**SERVICE BULLETIN 36
(Reprint)**

RE: Lethal Weapon 3 Flippers

SERVICE BULLETIN 36

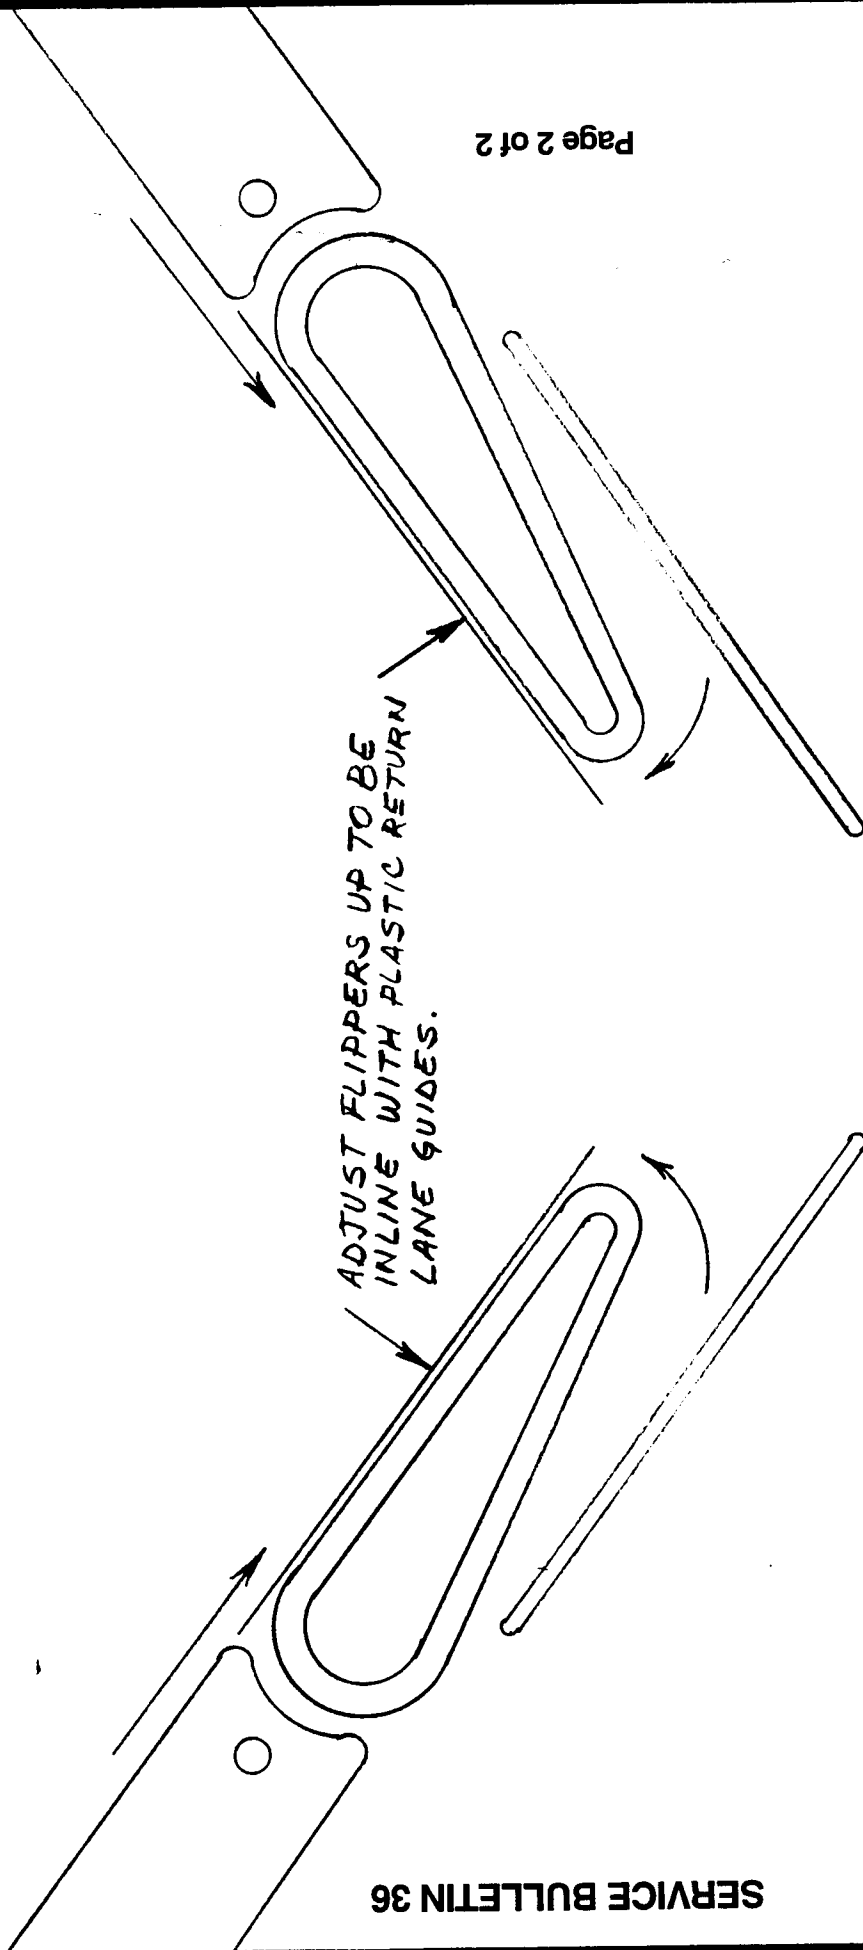
Symtom: The flippers appear weak on some Lethal Weapon 3 games, making it difficult to complete the ramp shot(s).

Cause: The flipper bat is not aligned properly with respect to the return lane guides. The bats are probably pointed too low, resulting in an inadequate striking angle on the ball.

Solution: Loosen the socket head screw connecting the Plunger Link & Pawl Assembly to the bat and align each flipper with respect to the plastic return lane guides. (See attached drawing).

*ADJUST FLIPPERS UP TO BE
INLINE WITH PLASTIC RETURN
LANE GUIDES.*
